Solar Industry Perspectives on the JU Proposal for New Supplemental Anti-islanding Protection Methodology

Interconnection Technical Working Group

November 8, 2016

JU Proposal – Solar Industry Redline

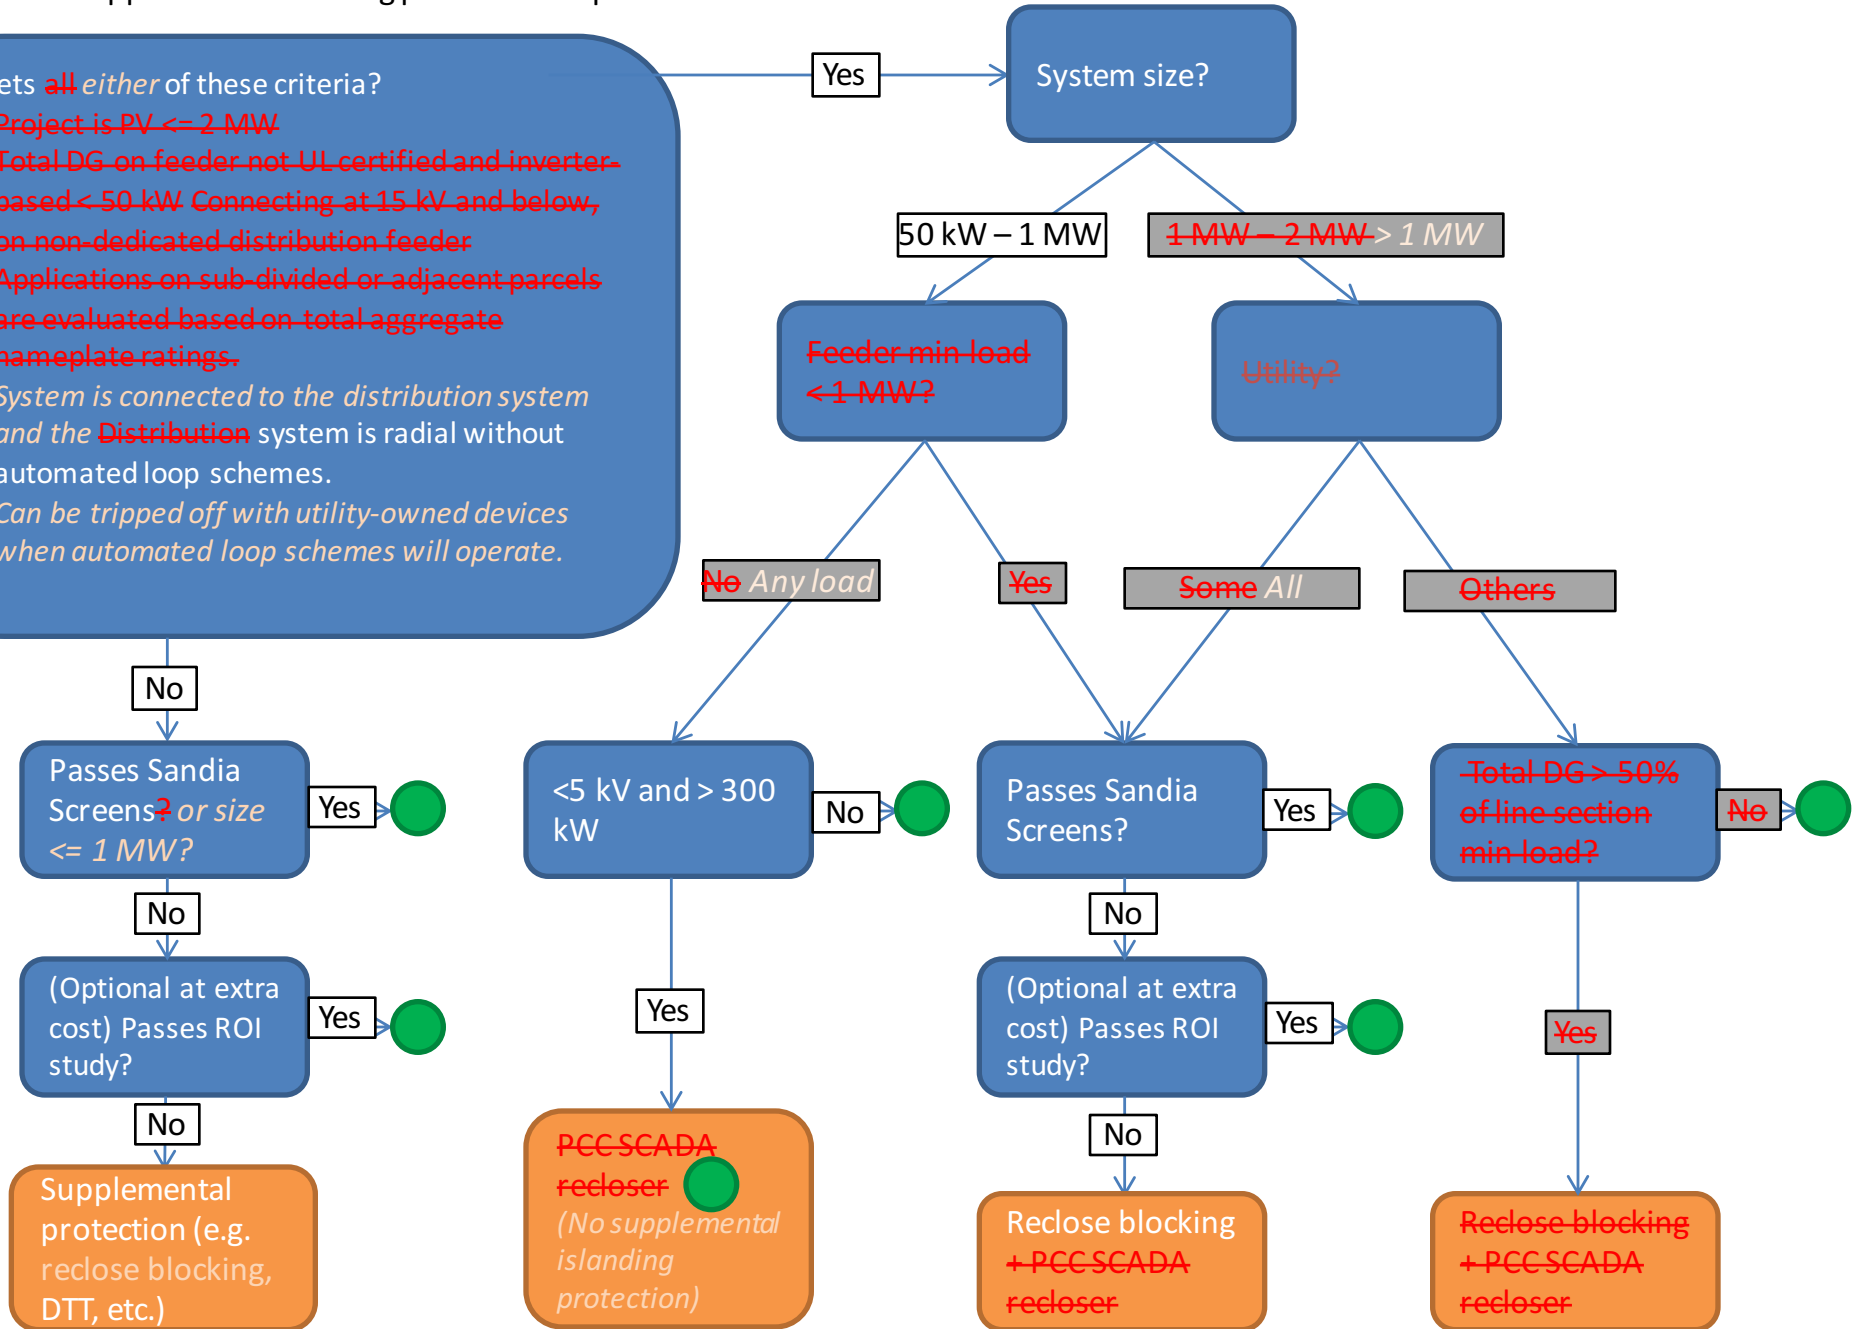
Meets ~~all~~ *either* of these criteria?

- ~~Project is PV <= 2 MW~~
- ~~Total DG on feeder not UL certified and inverter-based < 50 kW. Connecting at 15 kV and below, on non-dedicated distribution feeder~~
- ~~Applications on sub-divided or adjacent parcels are evaluated based on total aggregate nameplate ratings.~~
- System is connected to the distribution system and the **Distribution** system is radial without automated loop schemes.
- Can be tripped off with utility-owned devices when automated loop schemes will operate.

JU Proposal – Solar Industry Redline

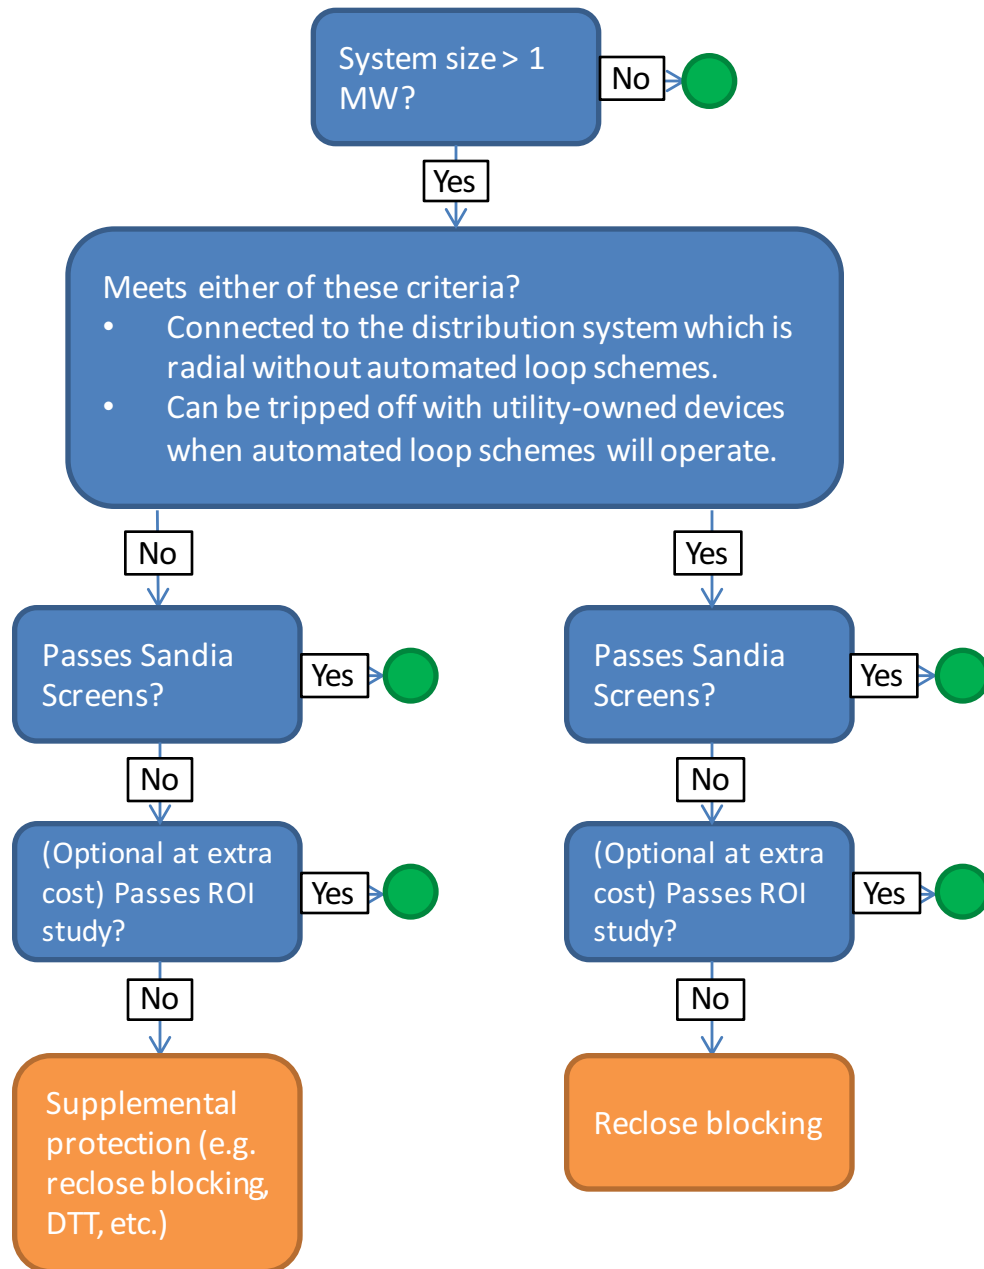
Questions concerning the aggregation of projects on subdivided or adjacent parcels

- The solar industry recognizes the goal of avoiding developers having the ability to game anti-islanding protection by breaking up one system into multiple parts on adjacent properties.
- The solar industry believes that our recommended elimination of the 2 MW cap on systems where reclose blocking is available in lieu of DTT and our proposed recommendations on systems below 1 MW will adequately address this potential issue
- **The solar industry recommends eliminating this element of the screening criteria**
